Subregional RTEP Committee – Western FirstEnergy Supplemental Projects

May 17, 2024

Changes to the Existing Projects

ATSI Transmission Zone M-3 Process East Akron Substation – s2297 Scope Change

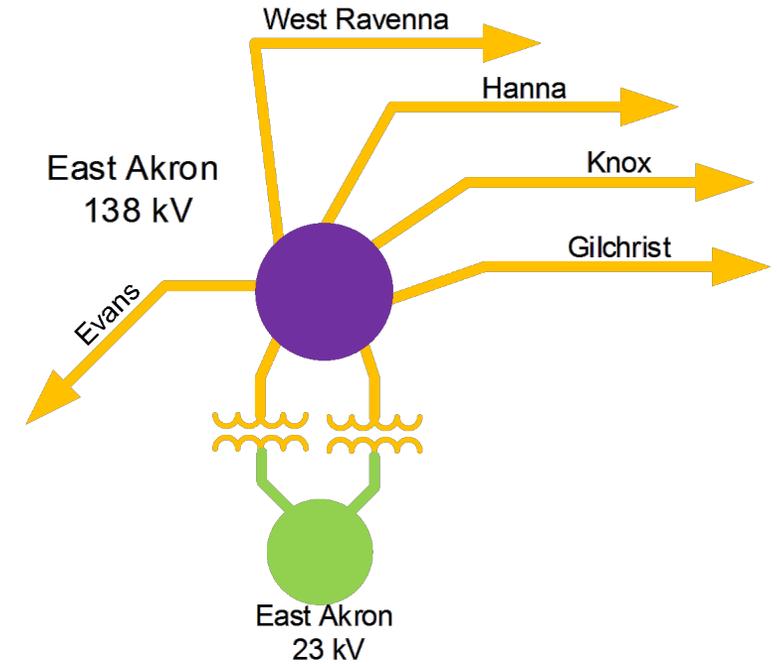
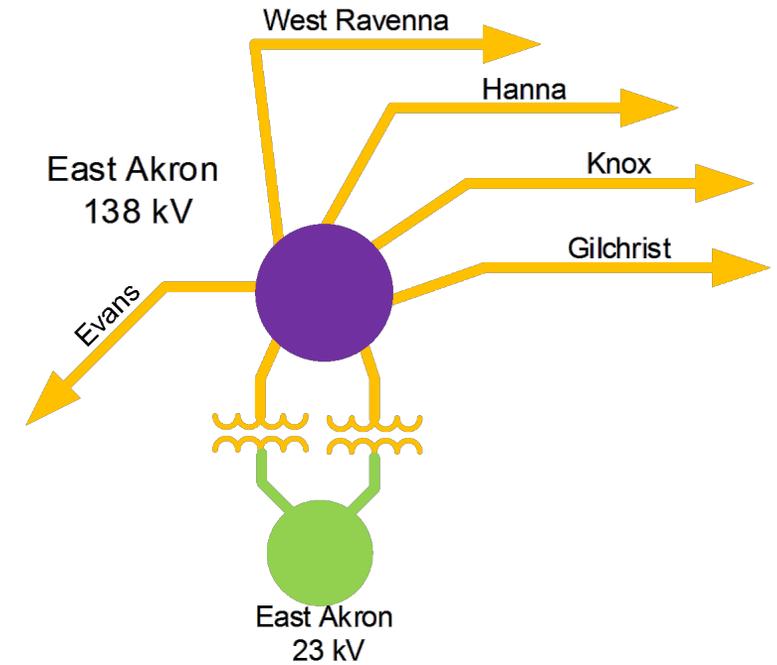
- Convert East Akron Substation into Breaker and Half configuration **with gas insulated equipment**
- Install a new control building.
- Re-use two (2) breakers (B75 & 76)
- Upgrade three (3) breakers (B43, B46 and B253) with 138 kV, 40 kA, SF6 circuit breaker
- Install seven (7) additional 138 kV, 40 kA, SF6 circuit breakers
- Replace and install switches, surge arrestors, CVT's, SSVT's
- Upgrade wave trap on Knox exit, replace line tuner and coax
- **Install new steel enclosure for the gas insulated equipment**
- **Expand fence**
- **Install 15 138 kV GIS breakers, 30 138 kV GIS motor operated disconnects, and one large prefabricated primary control enclosure**
- **Re-terminate five 138 kV circuits into new line positions**

- ~~East Akron - Hanna 138 kV Line~~
 - ~~Before Proposed Solution: 221 MVA SN / 262 MVA SE~~
 - ~~After Proposed Solution: 233 MVA SN / 282 MVA SE~~

Estimated Project Cost: ~~\$13.8M~~-\$46.70 M
 Projected IS Date: 12/18/2026
 Status: ~~Conceptual~~ Engineering
